Jersey Wharf – Jersey Street Ancoats

S96a Application - Design Changes

June 2025

Block A Courtyard Elevations

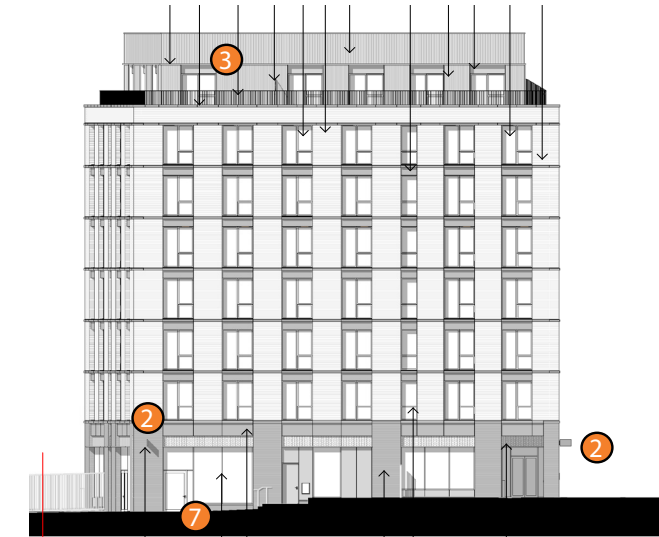
- ③ There have been minor updates to the setting out of windows within cladding on the 7th floor. This is so that the spacing of windows works with cladding sheet sizes.
- ⑧ Door changed from double to single leaf door to comply with Part M of building regulations.

Block A East and West Elevations

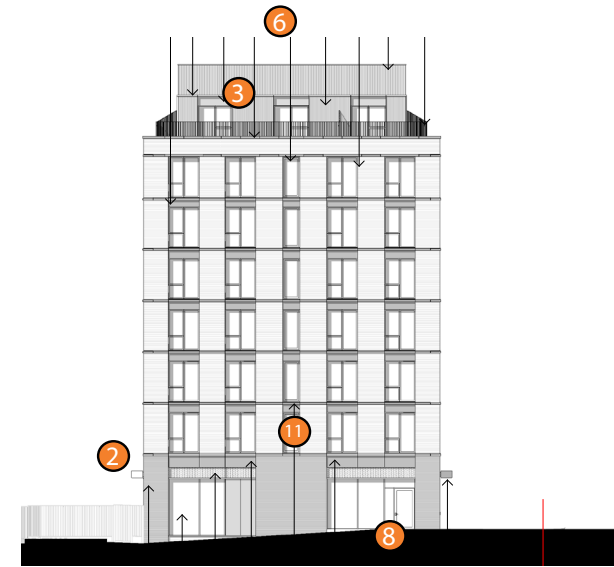
- ② Update to commercial unit signage. Commercial unit signage fixed to curtain walling has been replaced by projection signage fixed to brick piers.
- ③ There have been minor updates to the setting out of windows within cladding on the 7th floor. This is so that the spacing of windows works with cladding sheet sizes.
- ⑦ Door moved from commercial unit South Elevation to East Elevation in order to meet the requirements of Part M of building regulations.
- ⑨ Louvres removed from plant room doors as not required for ventilation strategy to these rooms.

Bay Study Elevations

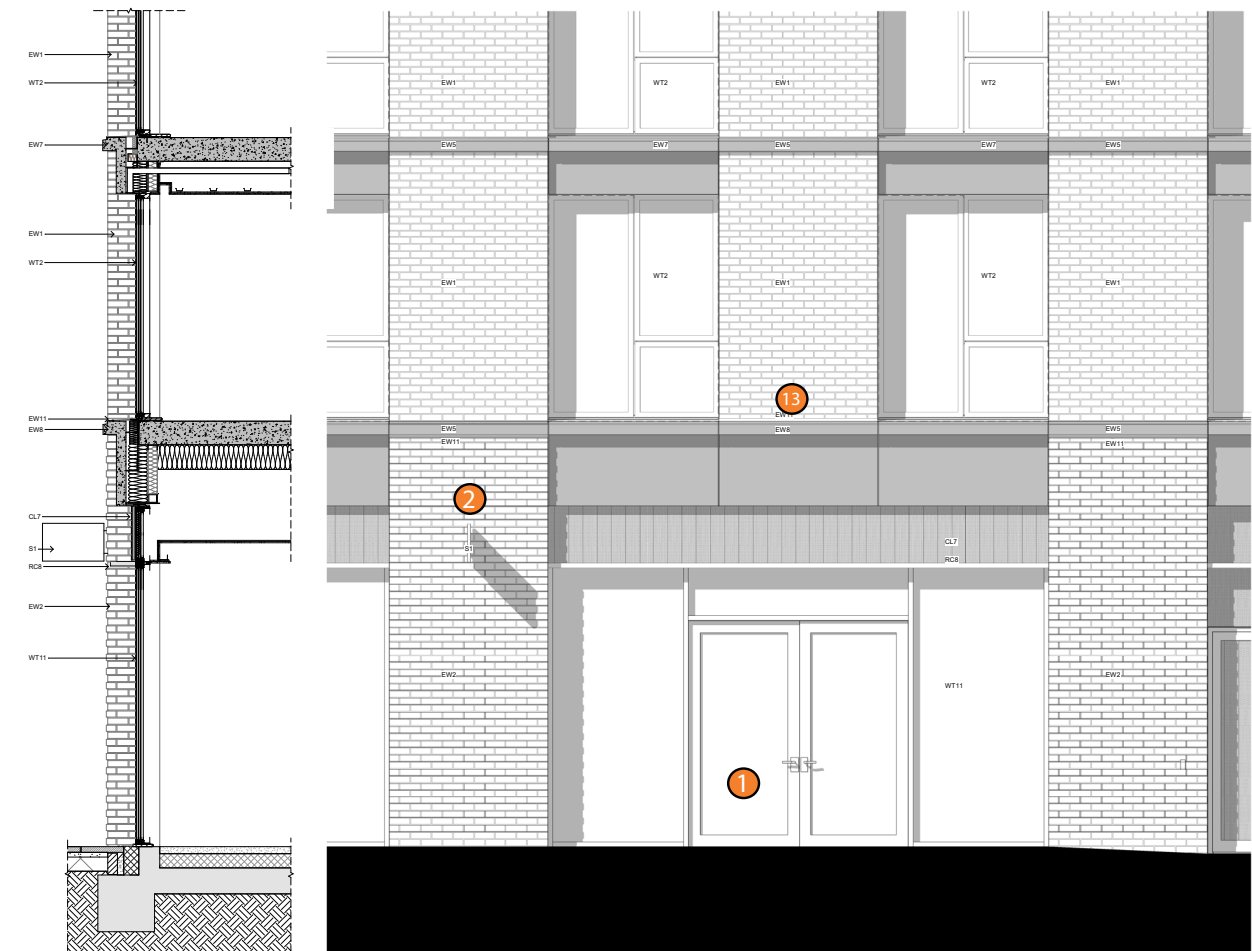
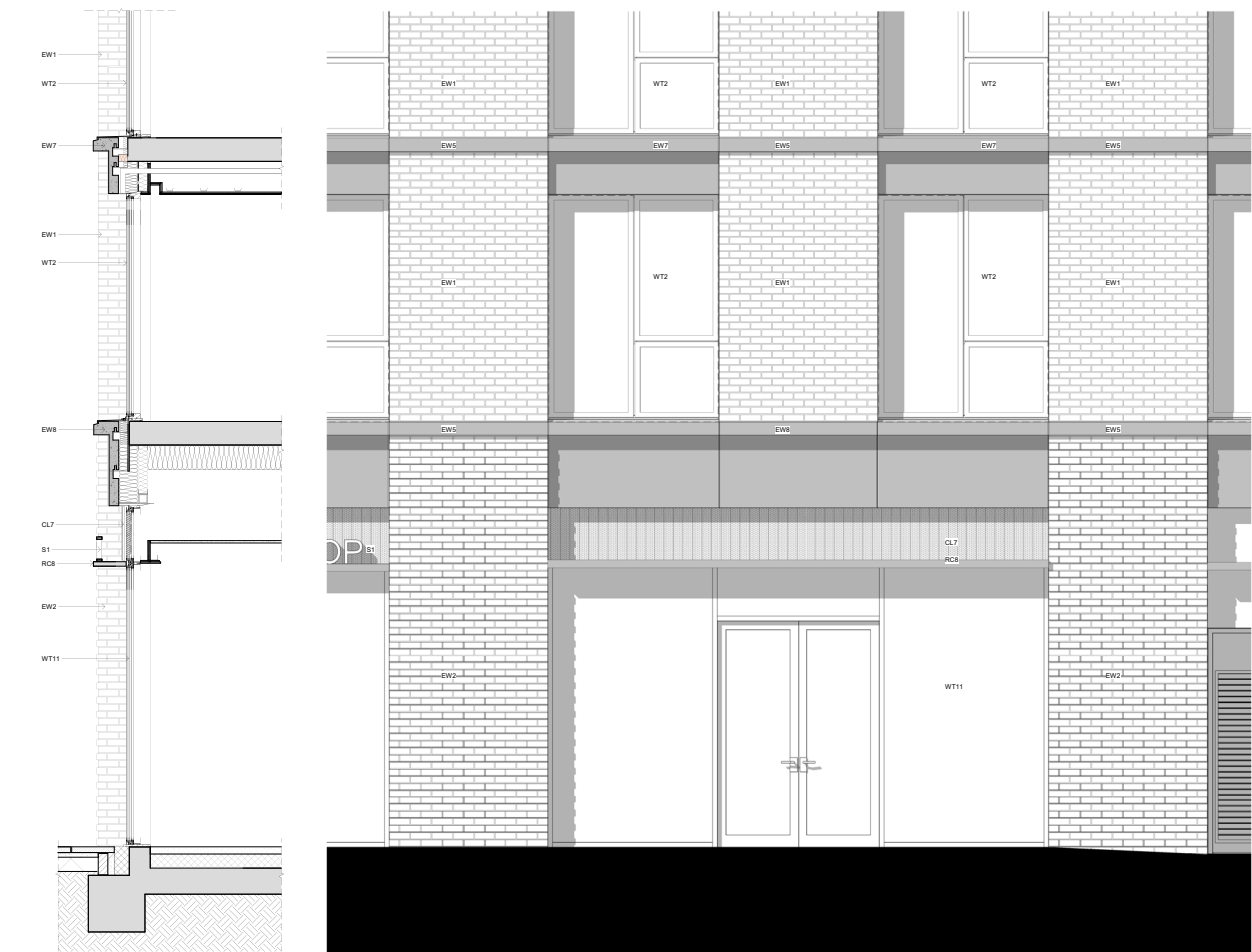
- 1 The opening size of the double doors into the commercial units has increased in width. This is to comply with the clear width requirements of Part M of the building regulations.
- 2 Update to commercial unit signage. Commercial unit signage fixed to curtain walling has been replaced by projection signage fixed to brick piers.
- 13 30mm horizontal movement joint required to meet structural deflection requirements. Colour to match mortar.

Site Plan

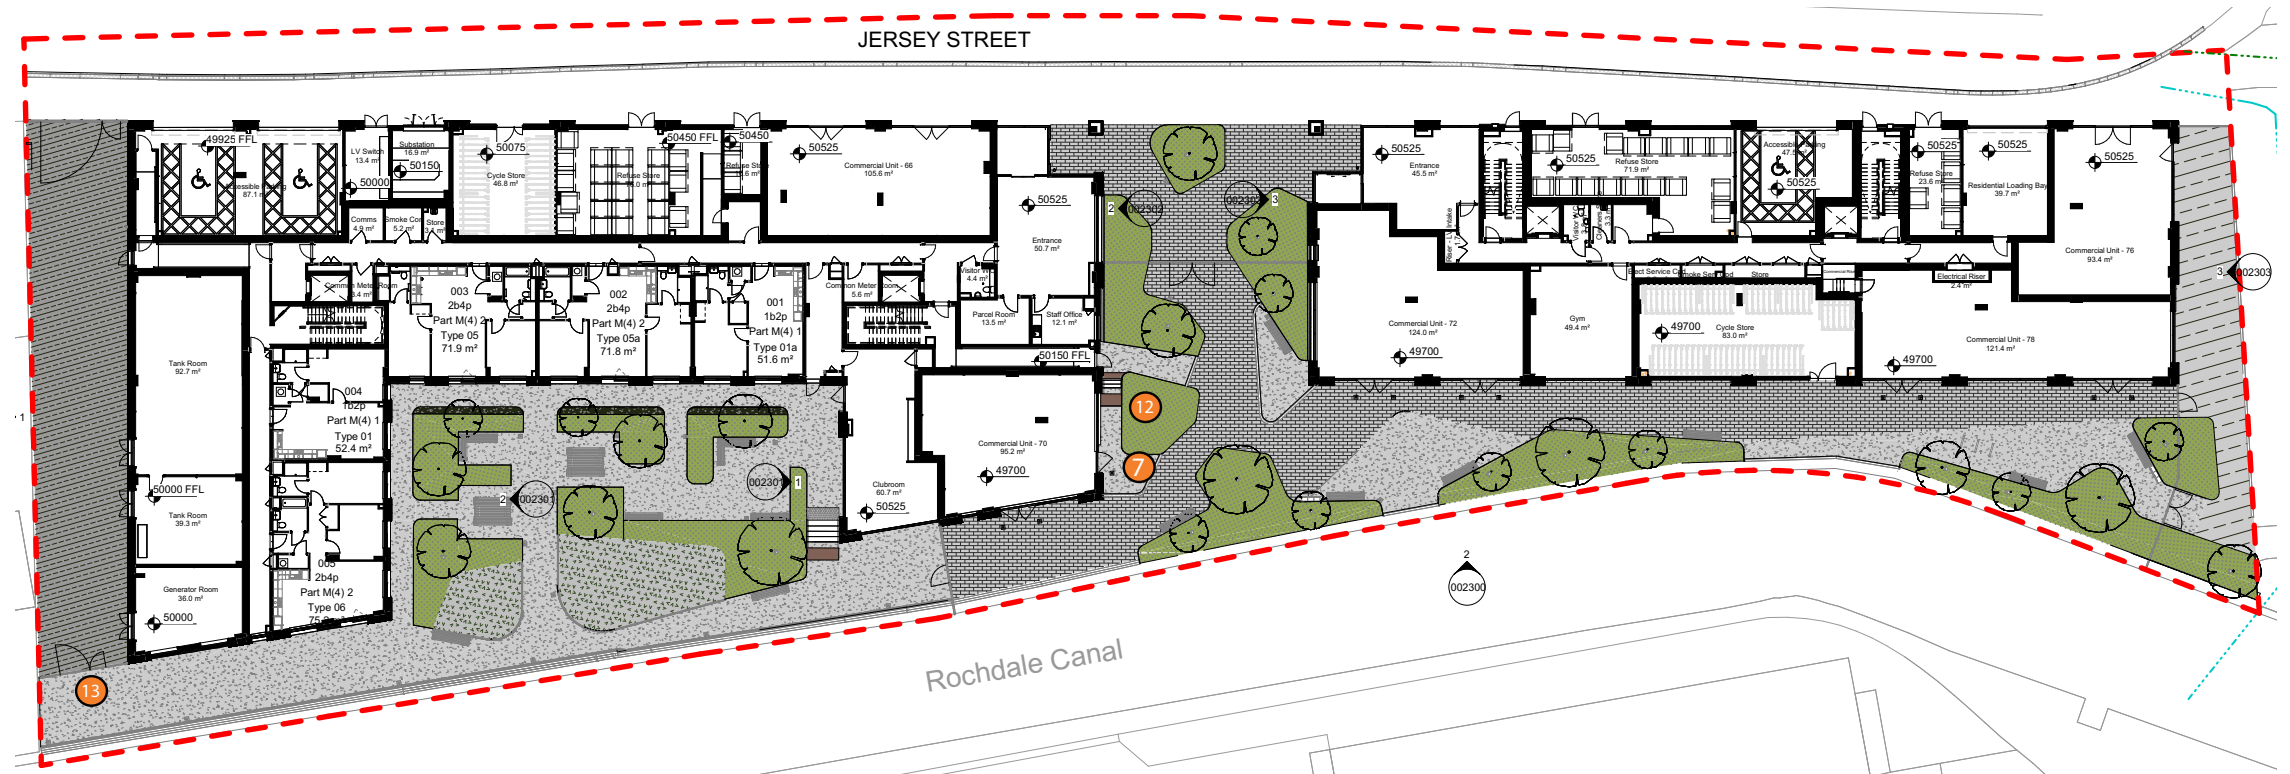
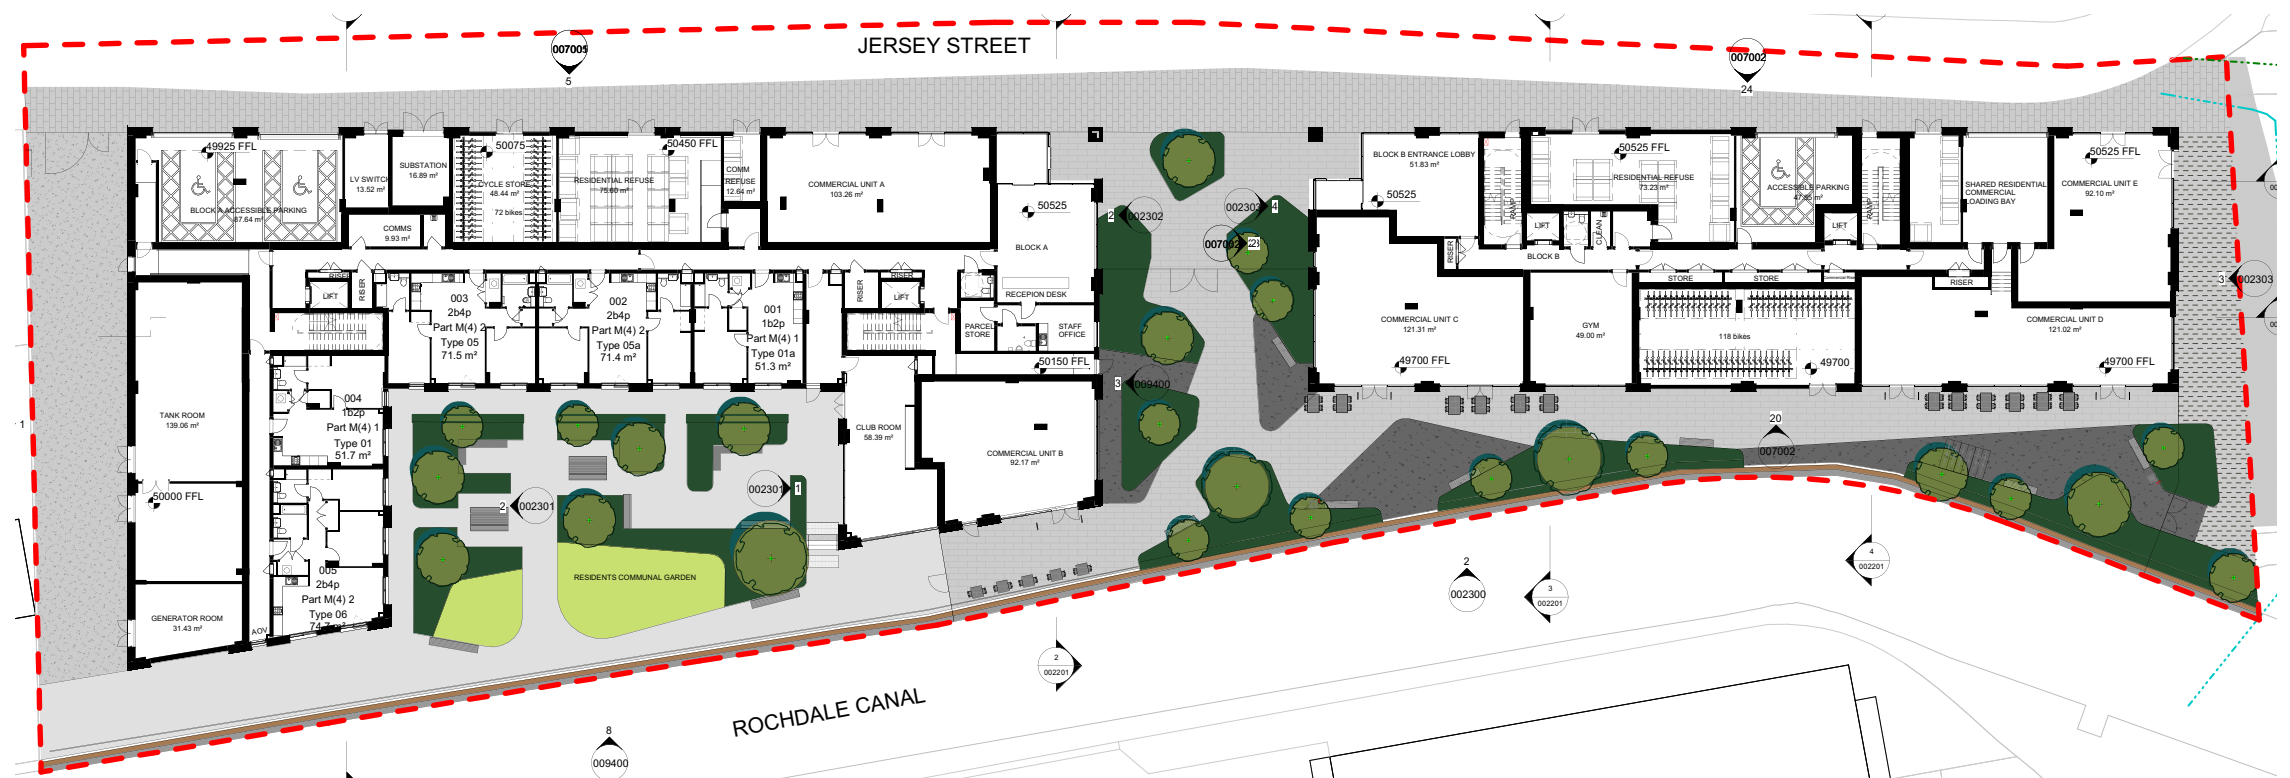
- 7 Door moved from commercial unit South Elevation to East Elevation in order to meet the requirements of Part M of building regulations.
- 12 Minor changes to the size of planter adjacent to commercial unit door and additional external steps added to facilitate access.
- 13 Additional gate added to restrict vehicle access to the canal edge.
